Preliminary Plan, 509 & 513 Harding Drive, 120110250

Completion Date: November 18, 2011

- 509 & 513 Harding Drive;
- 1996 Four Corners Master Plan, approximately 0.5 acres in total;
- A request for resubdivision of one recorded lot and one unrecorded parcel for a lot line adjustment between two properties zoned R-60; each property is developed with a single-family detached dwelling unit;
- Applicants – Jose and Isabel Teixeira, George Barnes;
- Filing Date – 6/16/11.

**RE-SUBDIVISION OF
LOT C1 AND PARCEL 917
FAIRWAY, SECTION 4**

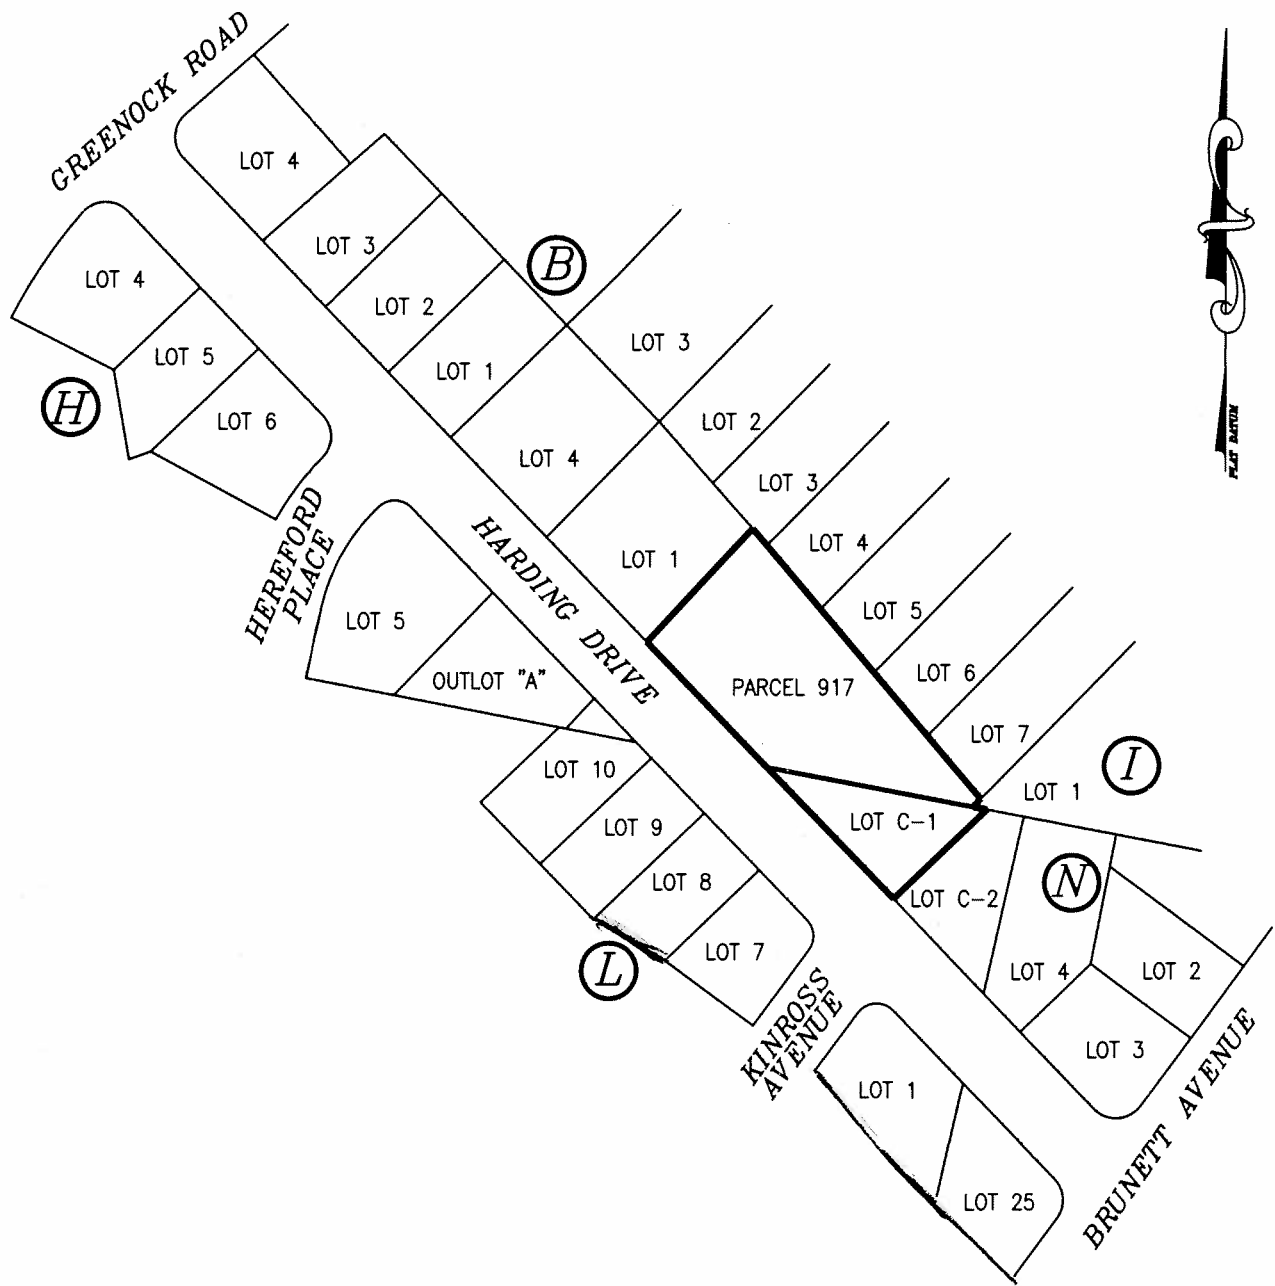
1. Show/label all existing planimetric and topographic details specifically driveways adjacent and opposite the site as well as existing rights of way on both sides on the preliminary plan.
2. The sight distances study has been accepted. A copy of the accepted Sight Distances Evaluation certification form is enclosed for your information and reference.
